## **Item 9: Far West Texas Regional Planning Group (RPG) Project**

Board of Directors Meeting

**Date:** June 6, 2017  
**To:** Board of Directors  
**From:** Prabhu Gnanam, Manager, Transmission & Interconnection Studies  
**Subject:** Far West Texas Regional Planning Group (RPG) Project

# ERCOT Independent Review of the AEPSC and Oncor Far West Texas Project

Figure 2.2: Proposed Far West Texas Project

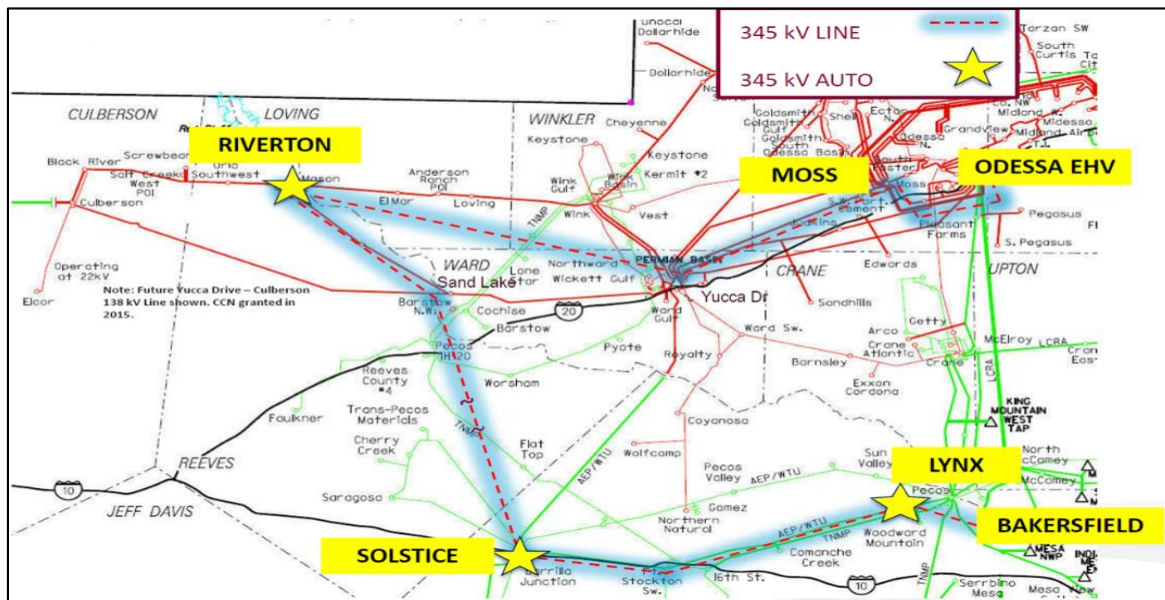
On April 20, 2016, Oncor and AEPSC submitted the Far West Texas Project (FWTP) to the Regional Planning Group (RPG) to address the transmission needs both in the Barilla Junction area and the Wink – Culberson – Yucca Drive 138 kV transmission loop (“Culberson loop”). This project was estimated to cost \$423 million and was classified as a Tier 1 project. Figure 2.2 shows the proposed FWTP. The major components of this project proposal were:

- A new 101-mile Odessa EHV – Riverton 345 kV line on a double circuit structure with a single circuit installed
- Expansion of the Riverton Switch Station to install a 3-breaker 345 kV ring-bus arrangement with one 600 MVA, 345/138 kV autotransformer
- Expansion of the Solstice Switch Station to install a 3-breaker 345 kV ring-bus arrangement with one 675 MVA, 345/138 kV autotransformer
- A new 66-mile Riverton – Solstice 345 kV line on a double circuit structure with a single circuit installed
- A new 345 kV Lynx Switch Station with a 5-breaker 345 kV ring-bus arrangement and one 675 MVA, 345/138 kV autotransformer
- A new 59-mile Solstice – Lynx 345 kV Line on a double circuit structure with a single circuit installed
- A new 9-mile Lynx – Bakersfield 345 kV Line on a double circuit structure with a single circuit installed

Based on the FWTP proposal, ERCOT completed this independent review to determine the system needs in the Barilla Junction and Culberson loop areas and address those needs in a cost-effective manner while providing the flexibility to meet potential load and generating capacity growth in this region.

**Figure 4.1: Study Case Thermal Violations in Study area**

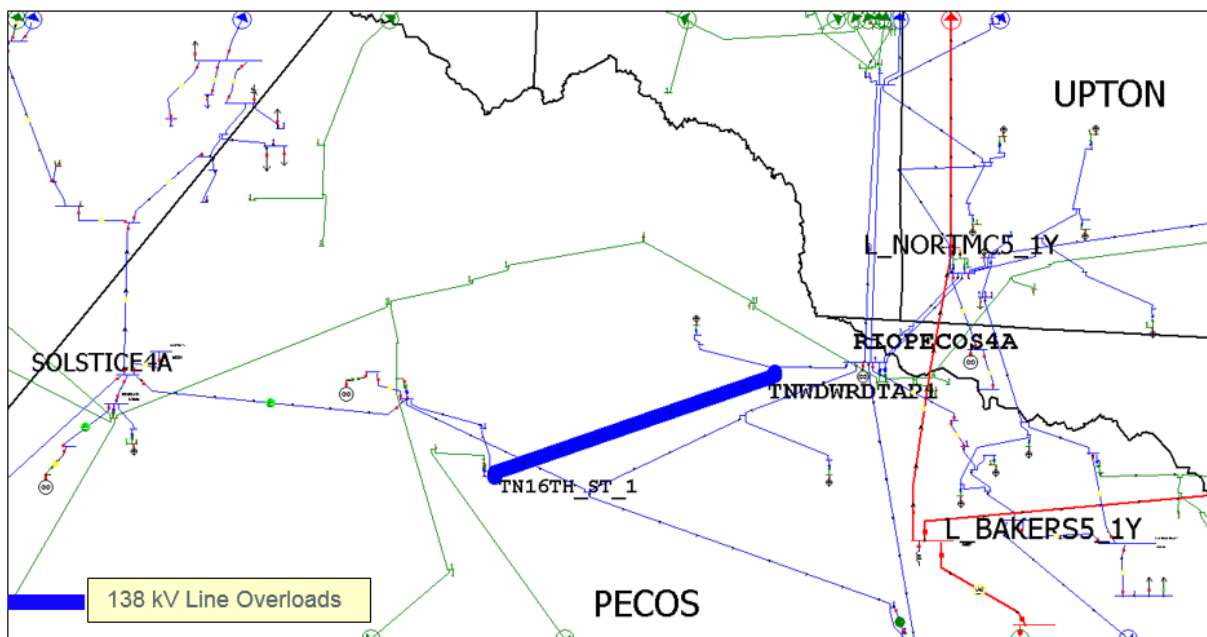
The need for a transmission improvement project was evaluated for the Study Case with both the base case and “No Solar” scenarios. The steady state analysis results showed transmission line overloading in the Barilla Junction area and voltage instability (unsolved contingencies) in the Culberson loop area under N–1 contingency analysis. The results of the steady state violations are summarized in Tables 4.1 – 4.4.

Figure 4.1 shows the thermal violations seen in the Study case.

Figure 4.2: Study Case Voltage Violations in Study area

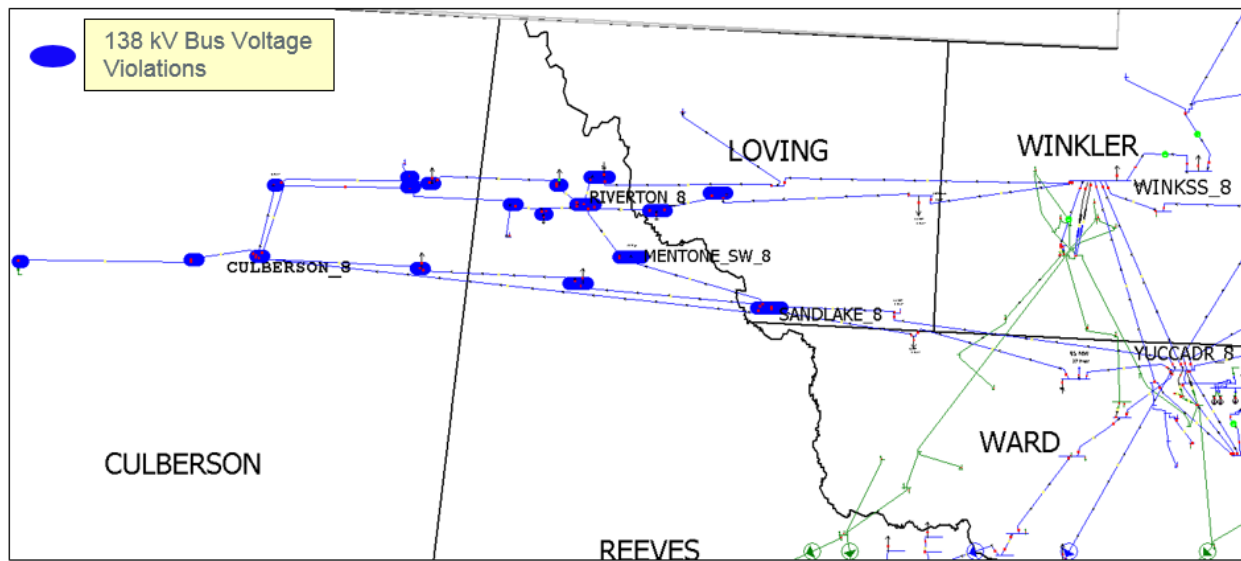
Figure 4.2 shows the voltage violations seen in the Study case.

Figure 4.3: No Solar Case Thermal Violations in Study area

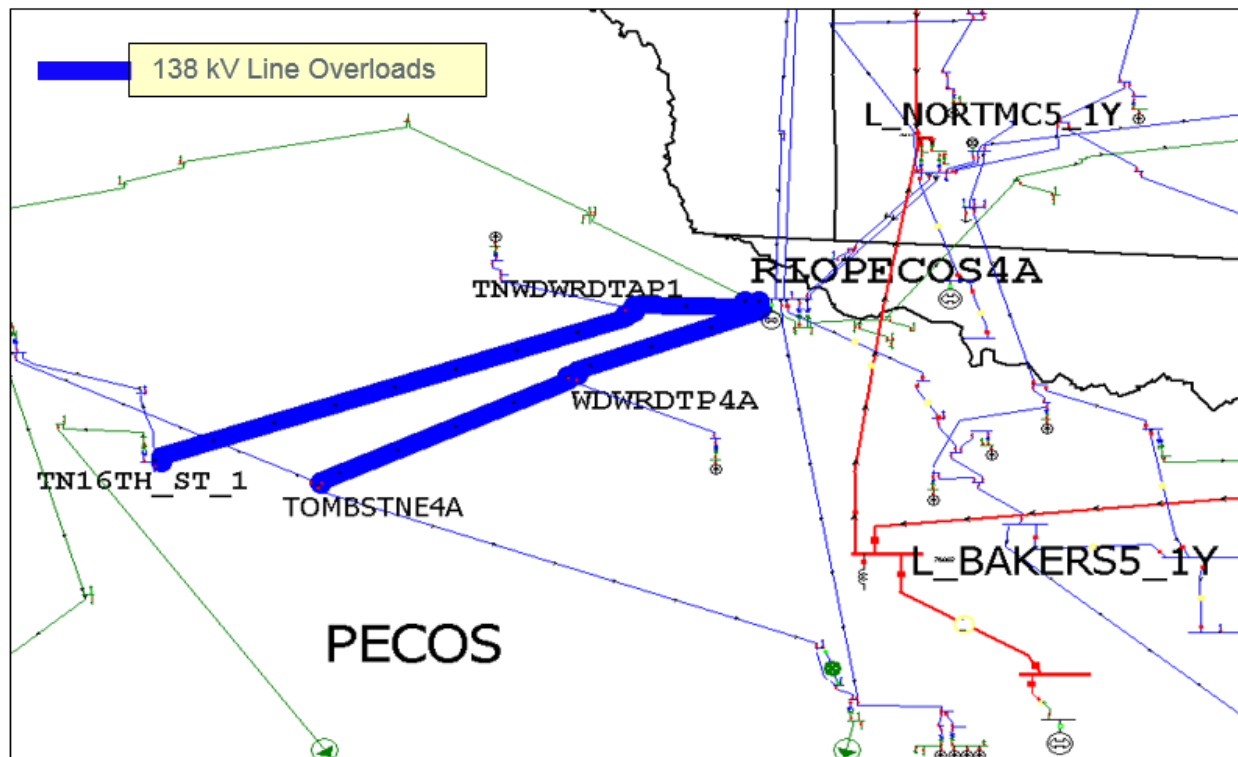
Figure 4.3 shows the thermal violations seen in the No Solar case.

Figure 4.4: No Solar Case Voltage Violations in Study area

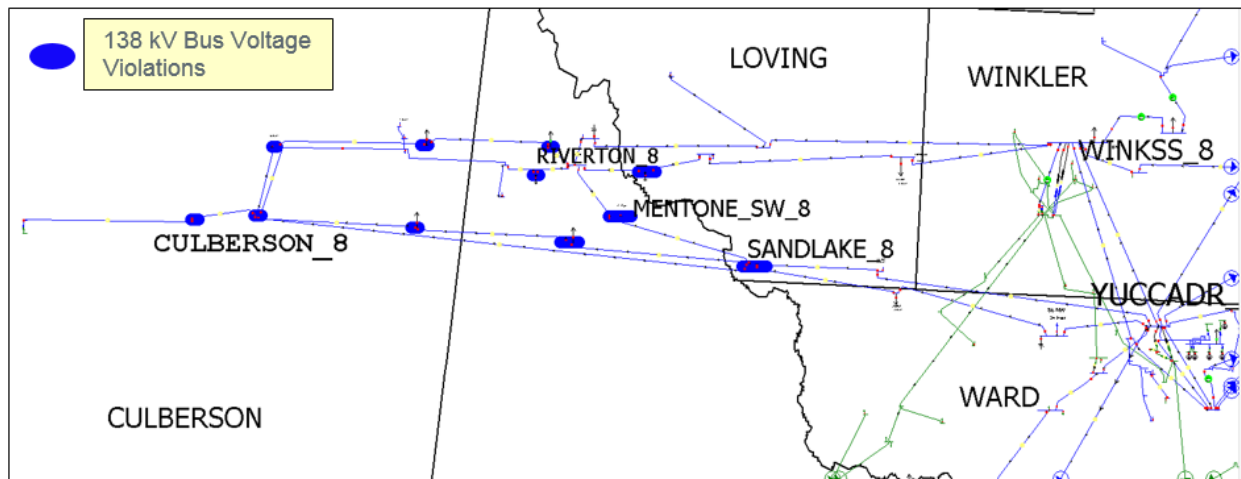
Figure 4.4 shows the voltage violations seen in the No Solar case.

Figure 9.1: Option 2 applied to the Study area

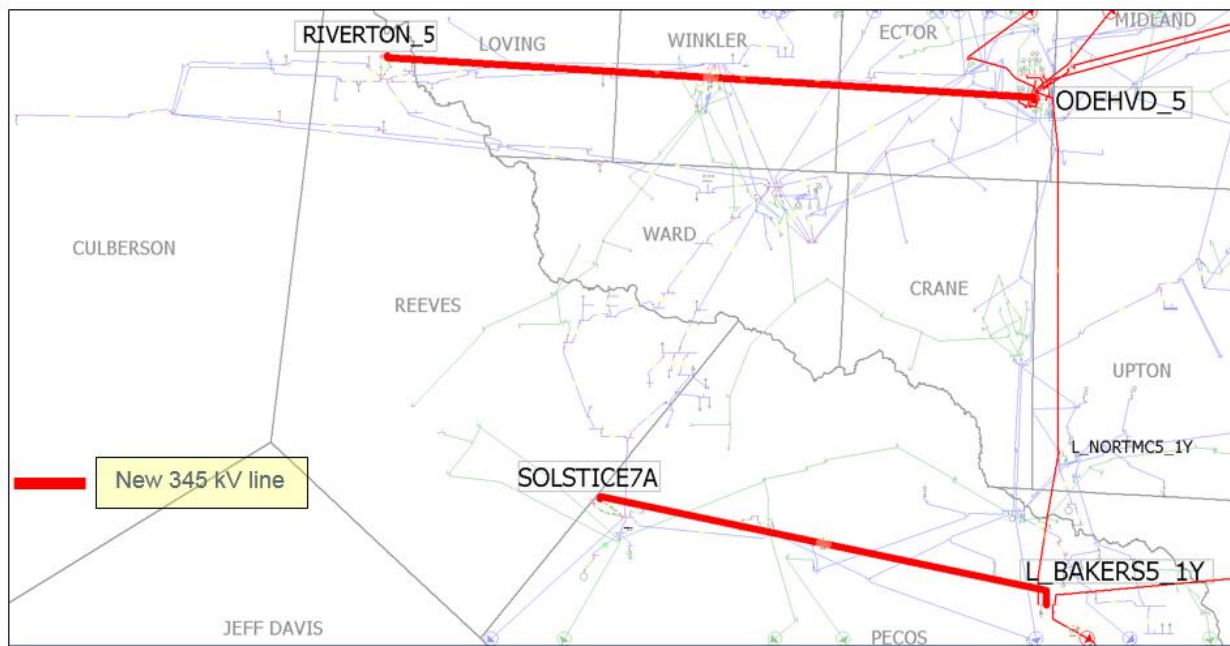
As shown in Table 9.1, a comparison of study results for the short-listed options shows that Option 2 met the system reliability criteria under the Study Case load conditions while deferring more than \$100 million in capital expenditures when compared to the other options. Option 2 also resulted in lower system production costs when compared to Option 1 and was expected to provide an adequate voltage stability margin.

Figure 9.1 shows Option 2 applied to the study area.

- Expand the Riverton Switch Station to install a 345 kV ring-bus arrangement with two 600 MVA, 345/138 kV autotransformer.
- Construct a new approximately 85-mile 345 kV line on double-circuit structures with one circuit in place, between Moss and Riverton Switch Station. Add a second circuit to the existing 16-mile Moss Switch Station – Odessa EHV 345 kV double-circuit structures. Install 345 kV circuit breaker(s) at Odessa EHV Switch Station. Connect the new circuit from Riverton Switch Station and terminate at Odessa EHV Switch Station to create the new Odessa EHV – Riverton 345 kV Line.
- Expand the Solstice Switch Station to install a 345 kV ring-bus arrangement with two 600 MVA, 345/138 kV autotransformer.
- Construct a new approximately 68-mile 345 kV line from Solstice Switch Station to Bakersfield Station on double-circuit structures with one circuit in place.
